MALLORY SQUARE II APARTMENTS PARCEL 6 MASTER PLAN (AT TORREY PRESERVE)

Applicant's Request: Master Plan approval of the third phase of the Torrey Preserve PD, with a proposed 3-story ±280-unit townhouse-style apartments on Parcel 6 of the Torrey Preserve PD (northwest of the previously approved Parcel 11 Mallory Square apartments (MPL2020-10032), with direct access to Las Olas Ave. and Bal Bay Dr. and street tie-ins to other existing and future roadways within the Torrey Preserve PD.

Staff Recommendation: Approval of the Master Plan, subject to conditions in this staff report.

UPDATED SITE PLAN - MALLORY SQ. II APARTMENTS

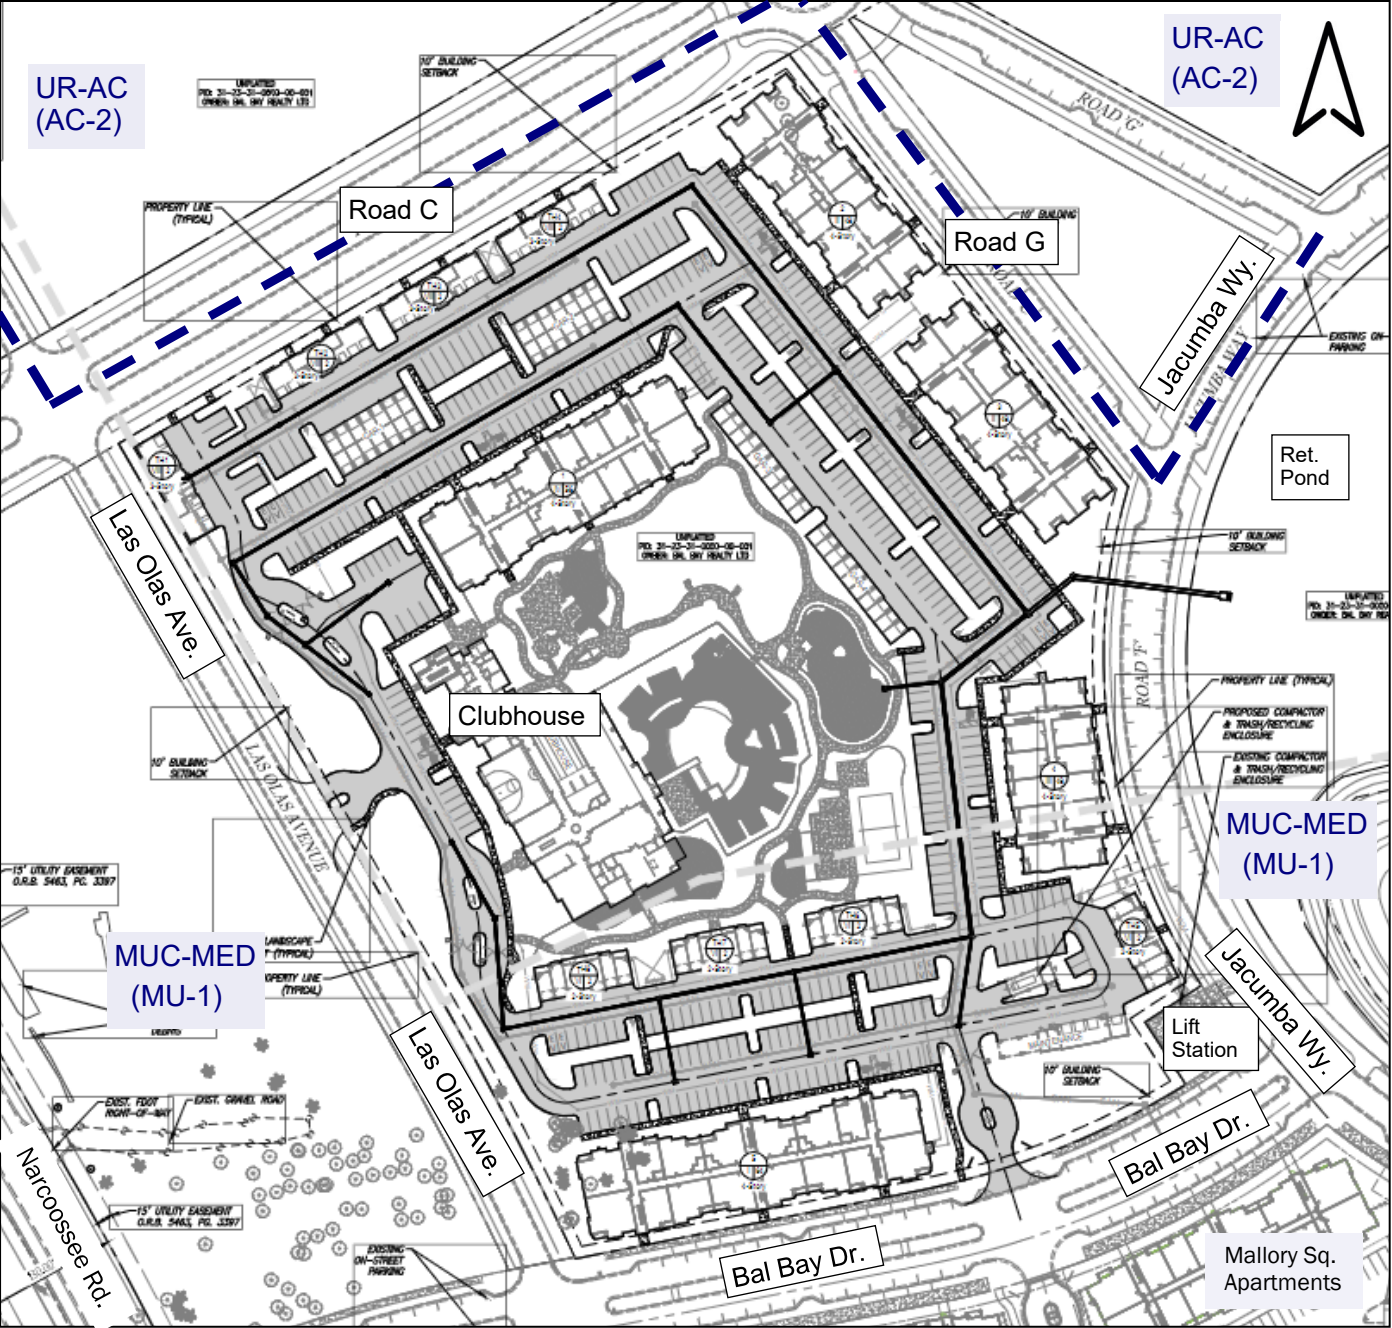
16. (Condition removed, based on revised site plan).
17. Backflow preventer[s] must be located to not be directly visible from the right-of-way or should be screened from view where necessary, thorough the use of walls, fences or hedging around all four sides. The utility plan at the time of permit must clearly show the location of all backflow preventers.

19. A photometric plan must be provided at time of permitting submittal.
20. The proposed site plan is currently non-dimensional (not to scale). The site plan provided at the time of permitting must have all dimensions clearly labeled. (The revised site plans meet this condition.)

PROPOSED PARCEL 6 APARTMENT ELEVATIONS

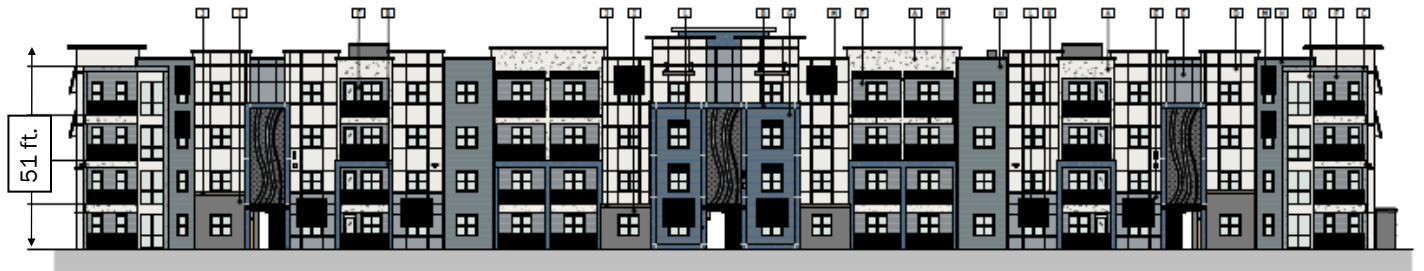
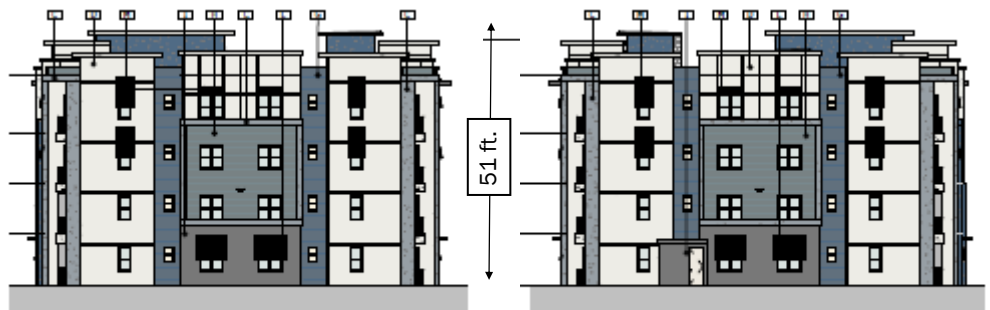
2. Every main entrance is required to have a special emphasis appropriate to the architectural style of the building.
3. All ground-mounted and rooftop mechanical equipment must be screened from view and must meet LDC screening requirements. An interior screen wall or parapet for rooftop mechanical equipment is required and must be the same height as the installed mechanical equipment. Several of the multi-family buildings still show visible mechanical equipment.

4. All projecting parapet walls must wrap a minimum depth of 5 ft. or more, whichever is proportionate to the parapet wall, in efforts for the projecting parapet walls to appear 3-dimensional.

9. A minimum 15% transparent material is required on all façades facing a public street, private street, or courtyard, on each story below the roof line. A minimum 10% transparent material is required on all interior side façades on each story below the roof line. As proposed, additoinally transparency would be

CLUBHOUSE ELEVATIONS

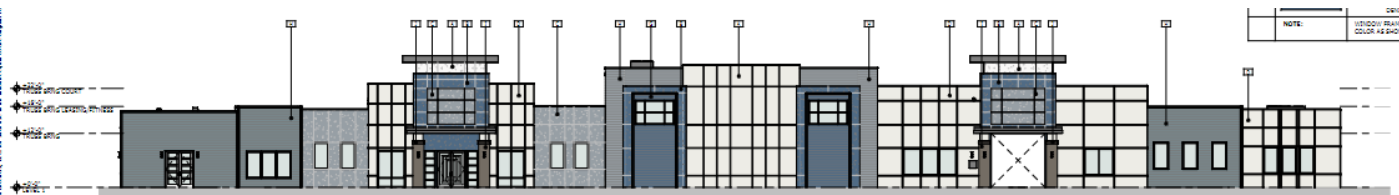
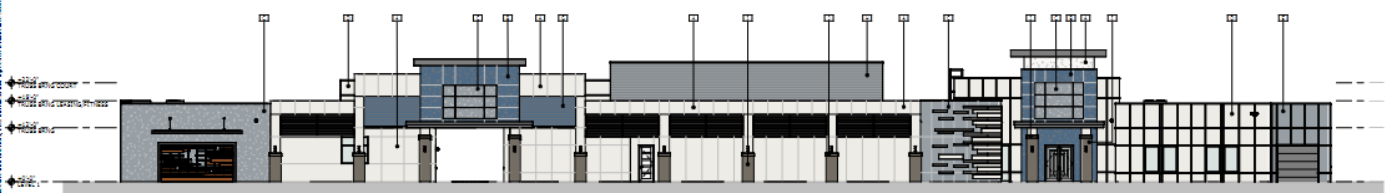
6. Deviation from submitted elevations will require an additional Appearance Review determination prior to permitting.
7. Accessory Buildings: Architectural elevations of the clubhouse, mail kiosk(s), trash compactor(s), or similar accessory structures must be compatible and consistent with the residential buildings, and must be expressed with similar finishes, forms, materials, and colors.

LANDSCAPE PLAN FOR MALLORY SQ. II APARTMENTS

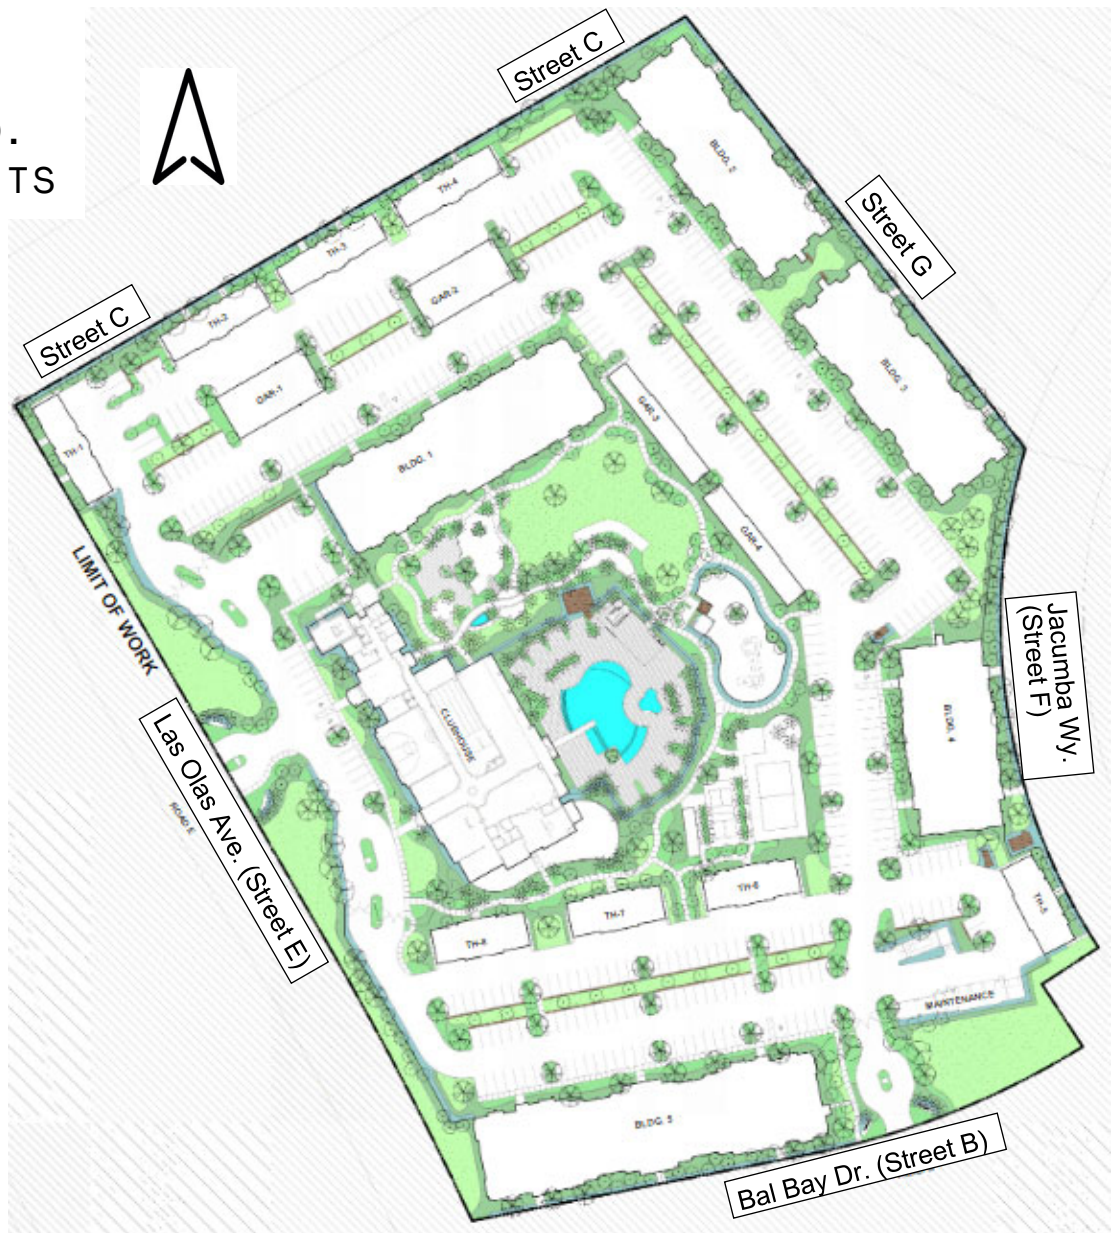
22. All landscape plans must achieve the Minimum Required Landscape Score (MRLS) required for multi family and nonresidential uses and must comply with the LDC Chapters 60 and 61. A spreadsheet showing compliance with the MRLS must be included with the plans. All existing, non-invasive matures trees should be preserved to the best extent possible.

23. Street trees are required along all street frontages. ROWs must be shown on the landscape plan submitted for building permits.
24. Row-end and intermediate landscape islands must be a minimum of 10 ft. in width.

25. Canopy trees are required in all parking lot row-end and intermediate landscape islands. Required trees must be a minimum 3-in. caliper and a minimum overall height of 12 ft.
